# UNITED STATES PATENT AND TRADEMARK OFFICE

APPLICATION NO.	FILING DATE	FIRST NAMED INVENTOR	ATTORNEY DOCKET NO.	CONFIRMATION NO.
10/825,224	04/16/2004	Johannes Petrus Martinus Bernardus Vermeulen	081468-0309212	7269
909	7590	08/08/2005	EXAMINER	
PILLSBURY WINTHROP SHAW PITTMAN, LLP P.O. BOX 10500 MCLEAN, VA 22102			MULLINS, BURTON S	
			ART UNIT	PAPER NUMBER
			2834

<b>Office Action Summary</b>	<b>Application No.</b>	<b>Applicant(s)</b>	
	10/825,224	VERMEULEN ET AL.	
	<b>Examiner</b>	<b>Art Unit</b>	
	Burton S. Mullins	2834

## DETAILED ACTION

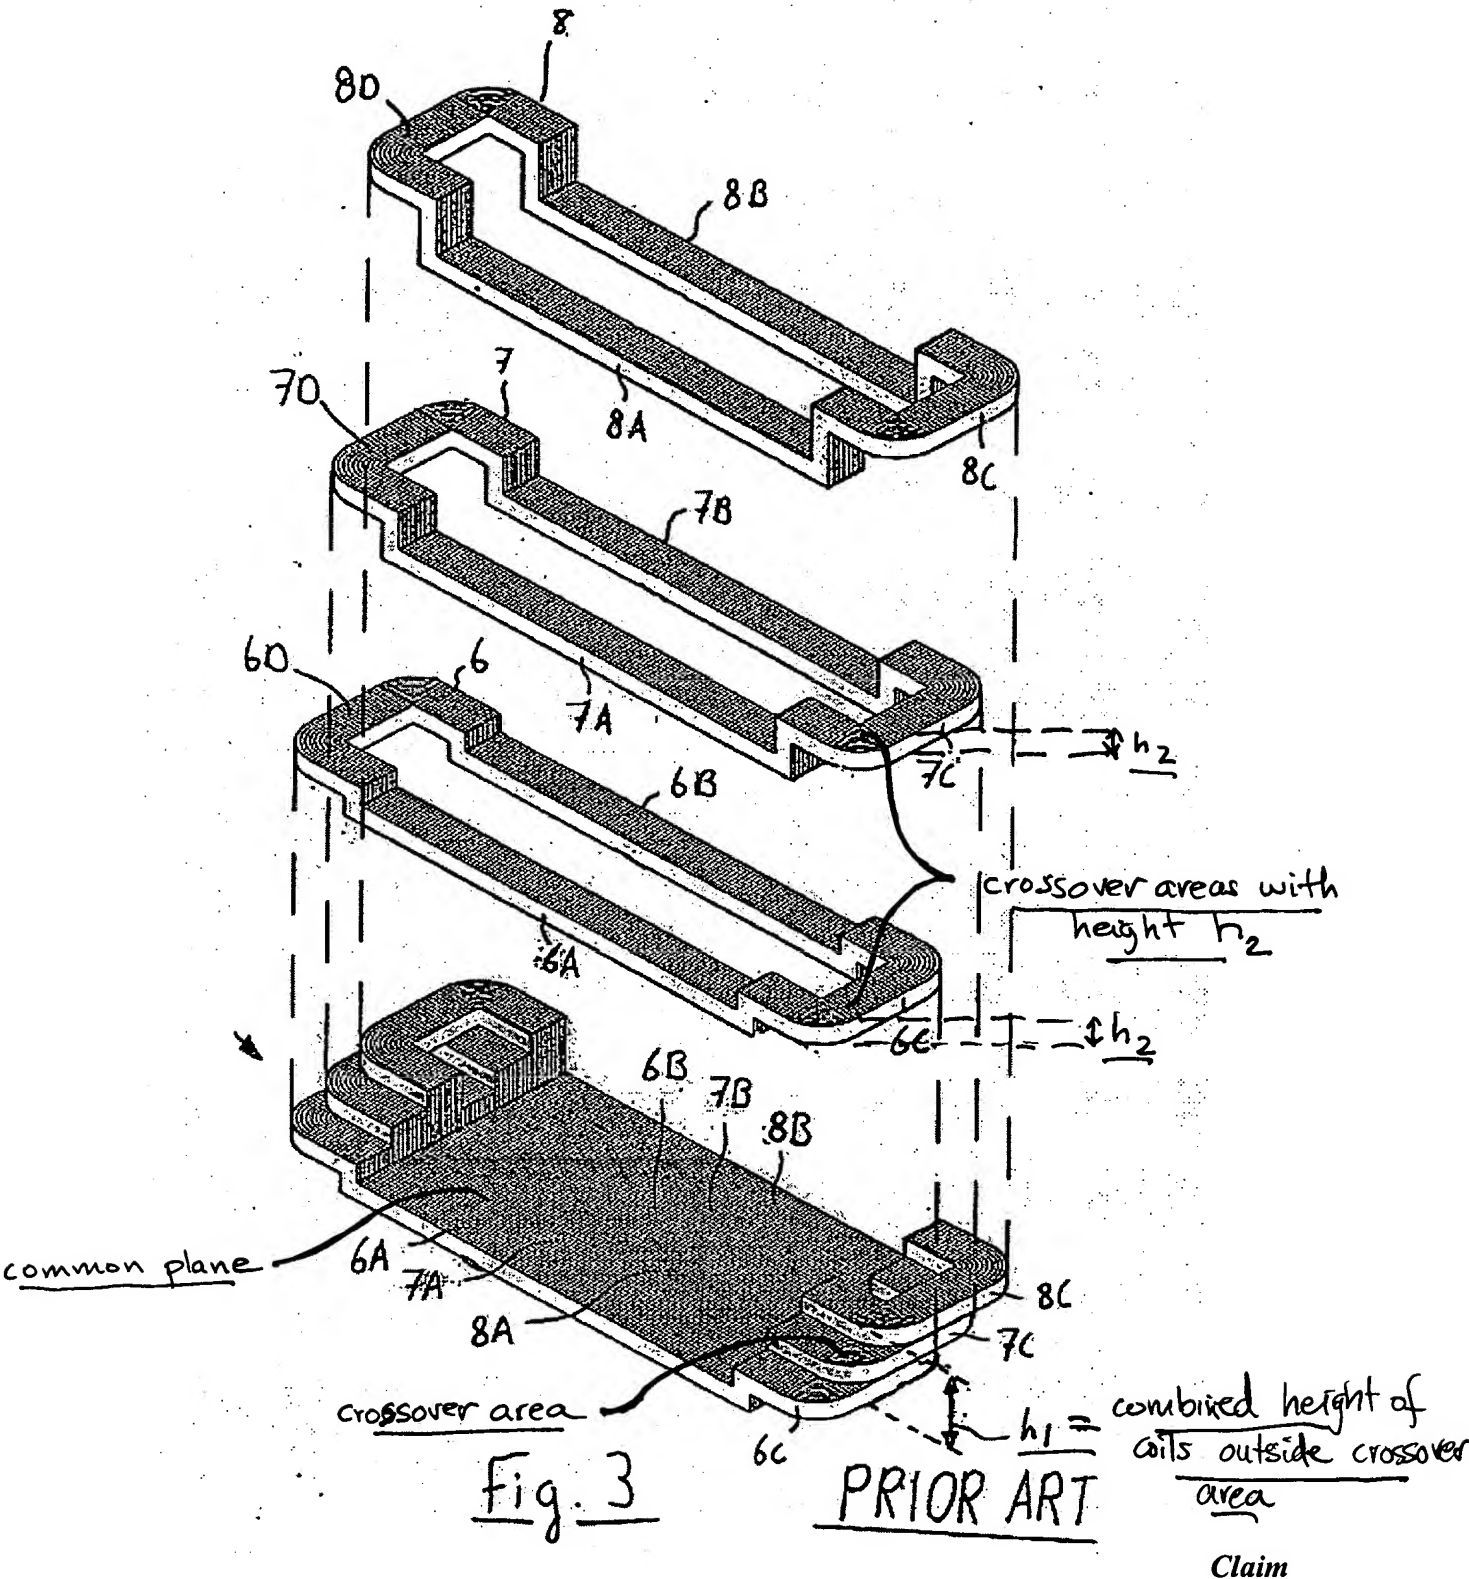
4. Claims 1-18, as best understood, are rejected under 35 U.S.C. 102(b) as being anticipated by applicant's admitted prior art. Figs.2-3 and pp.1-3 and 11-12 teach the prior art coil assembly including, with reference to the attached marked copy of Fig.3, at least one first coil (6); and at least one second coil (7), wherein the coils (6A/6B and 7A/7B) are arranged in a common plane, the at least one first coil and the at least one second coil overlapping one another partially and defining at least one crossover area where respective crossover sections of the at least one first coil (6) and the at least one second coil (7) cross one another, and the crossover sections having a respective crossover section height  $h_2$  perpendicular to the common plane, the combined crossover section heights of the crossover sections in the crossover area equal at most a height  $h_1$  (spec. p.11, last line-p.12, first line) of one of the at least one first coil and the at least one second coil outside the at least one crossover area.

**FIG. 5**

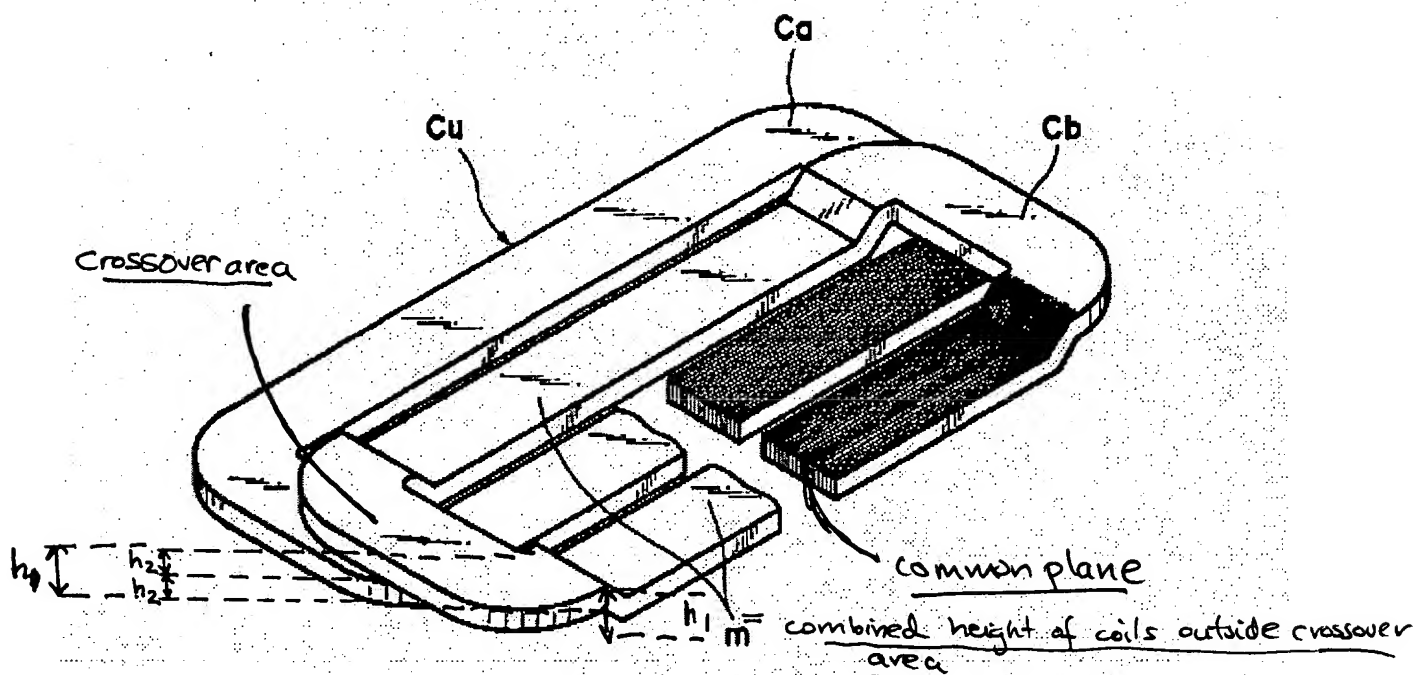
5. Claims 1, 3, 5-12 and 16-18, as best understood, are rejected under 35 U.S.C. 102(b) as being anticipated by Korenaga (US 6,265,793). Korenaga teaches a coil assembly (Fig.5) including at least one first coil (Ca); and at least one second coil (Cb), wherein the coils are arranged in a common plane, the at least one first coil and the at least one second coil overlapping one another partially and defining at least one crossover area where respective crossover sections of the at least one first coil and the at least one second coil cross one another, and the crossover sections having a respective crossover section height  $h_2$  perpendicular to the common plane, the combined crossover section heights of the crossover sections in the crossover area equal at most a height  $h_1$  of one of the at least one first coil and the at least one second coil outside the at least one crossover area.

Fig. 4

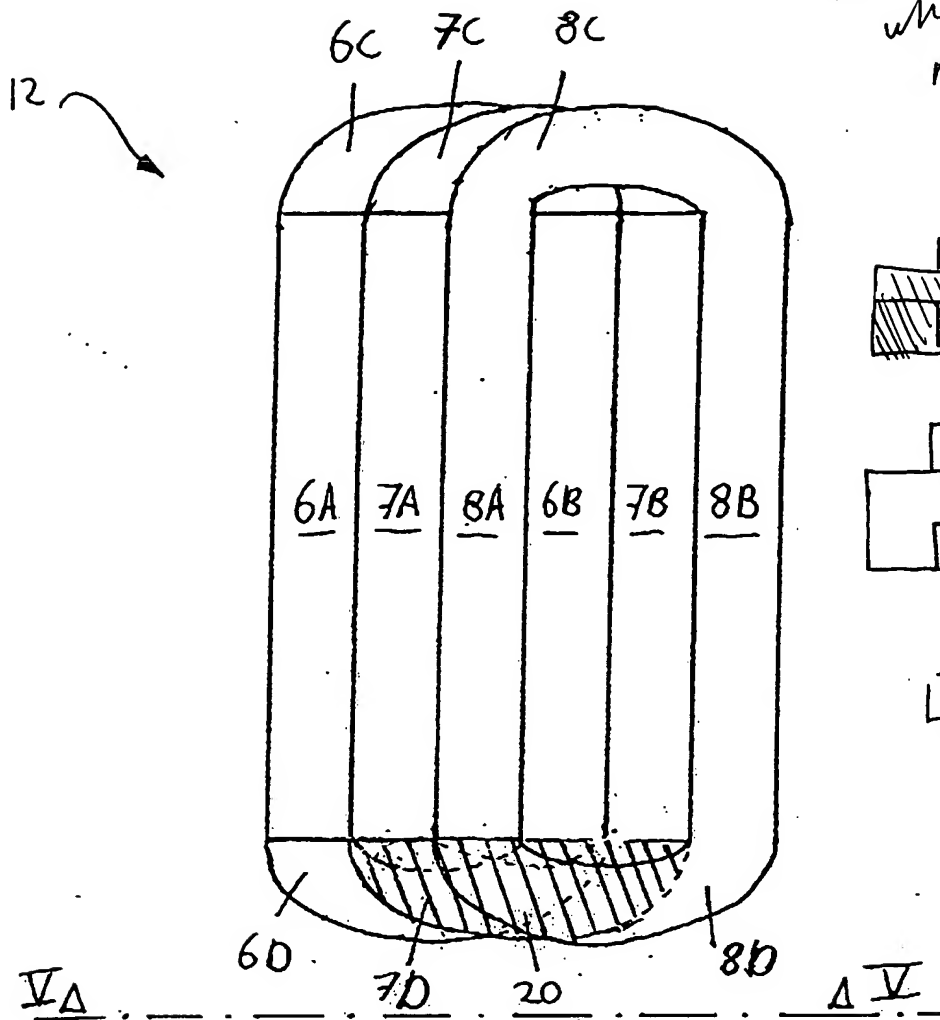
1. The drawings are objected to because Figs.4-5, while purporting to show the claimed invention, appear to simply show the prior art construction of Fig.3 from different perspectives. For example, h1 in Fig.3 is also shown in Fig.5 and refers to the same dimension, the total thickness of the crossover. Fig.4 appears to be a top view of the prior art coil system of Fig.3, with coil sections 7A/B and 8A/B placed in the open area of coil 6A/B, in the same plane. In other words, the drawings do not clearly show the features of the claimed invention.

not clear  
what applicant  
means or how  
crossover heights  
distinguish

Fig. 5

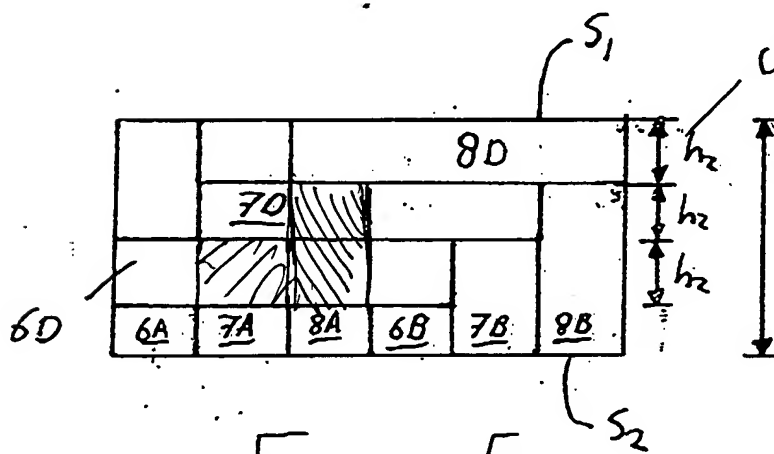
In claims 1, 8 and 10-11, recitation “the combined crossover section heights of the crossover sections in the crossover area equal at most a height of one of the at least one first coil and the at least one second coil outside the at least one crossover area” is vague and indefinite because it is not clear if this means the combined crossover section height, i.e.,  $h_2 + h_2 + h_2$  in Fig.5, is less than or equal to the total height of all the coils outside the crossover area, i.e.,  $h_1$  in Fig.5, or if the sum is less than the height of any one of the coils. The specification seems to suggest the former interpretation (see p.12, paragraph 53; Fig.5); however, the language “one of the at least one first coil and the at least one second coil” also implies an interpretation wherein the combined cross-over height is at most a height of either the first coil or the second coil. For purposes of examination, the former meaning will be taken, with the stated height limitation shown in Fig.5 as  $h_1$ . If the latter meaning is intended, the drawings should be corrected because  $h_1$  in Figs.3&5 currently denotes the height of all the coils outside the crossover area.

crossover height  
what is  $h_1$  combined  
heights outside  
 $3h_2 < h_1$   
~~area~~  
or just height  
of 1 coil outside  
x-over area??
